TMS 402/602 2022 Main Committee Minutes

First Session October 14, 2021

Date Issued: November 17, 2021

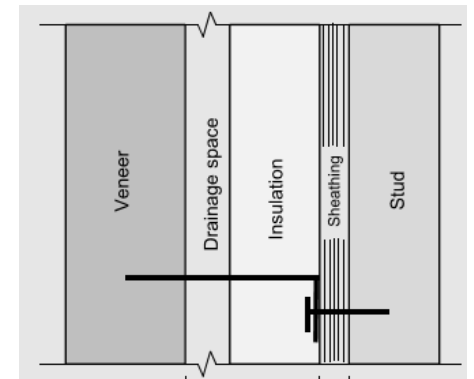
Comment 210 – "water penetration into the building"...What exactly is the extent of "into the building"...into the backing??...into interior space?? This statement must be consistent with the extent of water penetration permitted by the applicable building code. [Page 226, Line 66]

Comment 212 – "...entering into the building." What exactly is the extent of "into the building"...into the backing??...into interior space?? Such statements must be consistent with that permitted by the applicable building code. [Page 230, Line 88]

Biggs (NEG) – The drainage space does not include the insulation as shown on Figure CC-13.3.2. So to design, detail and construct the wall system to prevent water from penetrating beyond the drainage space means the insulation must become a water-resistive barrier. Normally, any barrier is placed under the insulation. TMS 602 also does not specify any insulation so the water-resistive characteristics are not mandated. I suggest changing the wording to "beyond the drainage space and insulation". Using "cavity" is not an option because unless Footnote 1 of Figure CC-13.2.4 is met, the water could go through the sheathing and be acceptable.

For new business next cycle, consider adding a water-resistive barrier to Fig CC-13-2.4 and change the wording to "beyond the water-resistive barrier".

13.2.1.8 Water Penetration Resistance — Flashing and weep holes in exterior veneer wall systems shall be designed and detailed to resist penetration of water ~~into the building interior~~ beyond the drainage space. A minimum 1 in. (25.4 mm)
